Re: PUC Docket No. 42935; Application of Manville Water Supply Corporation and Lakeside Water Control and Improvement District 2D ("*District*") for Approval of a Service Agreement in Travis County (37796-C)

Attachment A  
Revised CCN Maps and Revised Digital Data

LAKESIDE WCID 2D

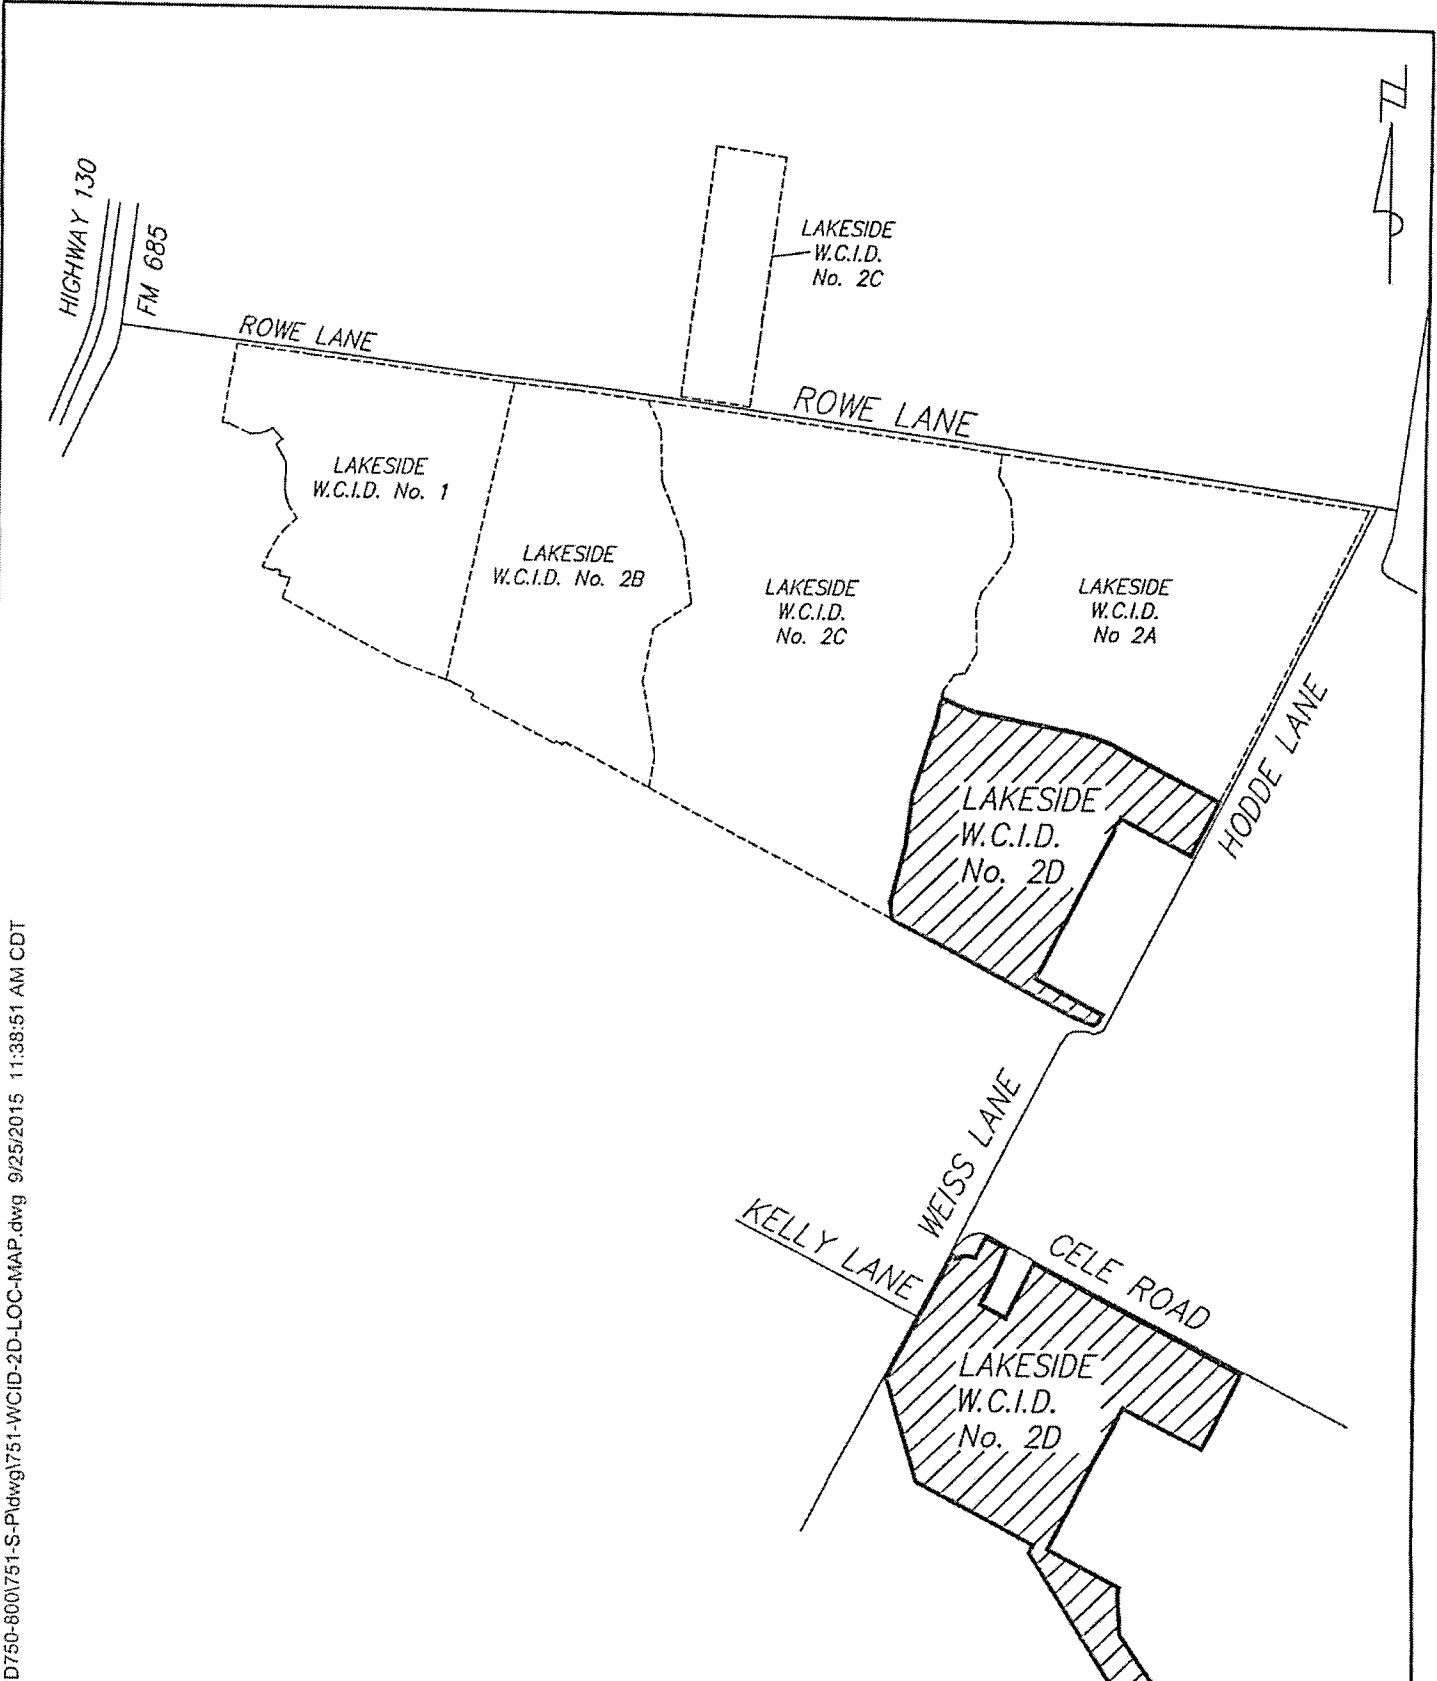
- A large scale (detailed) map delineating the proposed water and sewer service area for Lakeside WCID 2D with enough detail to accurately locate the service areas in the vicinity of surrounding roads, streets and highways. The proposed service areas requested for Lakeside WCID 2D must be clearly marked and labeled on the map differently than the surrounding Lakeside tracts, which are not associated with this docket.
- Proposed digital data only delineating the proposed service areas for Lakeside WCID 2D after removing the overlap with the City of Pflugerville's corporate boundaries.
  - a. Include the projection (PRJ) or coordinate system on a text file used to create the digital data.
  - b. Provide the digital data on a data disk (CD) as a singly polygon in a shapefile (SHP) format, which corresponds to the same proposed water and sewer service area as shown on the large scale map.

**RESPONSE:** The District is providing a revised CCN map and revised digital data, attached as Attachment A. These materials remove any proposed overlap with the City of Pflugerville's corporate boundaries and delineate the proposed water and sewer service areas specific to Lakeside WCID 2D.
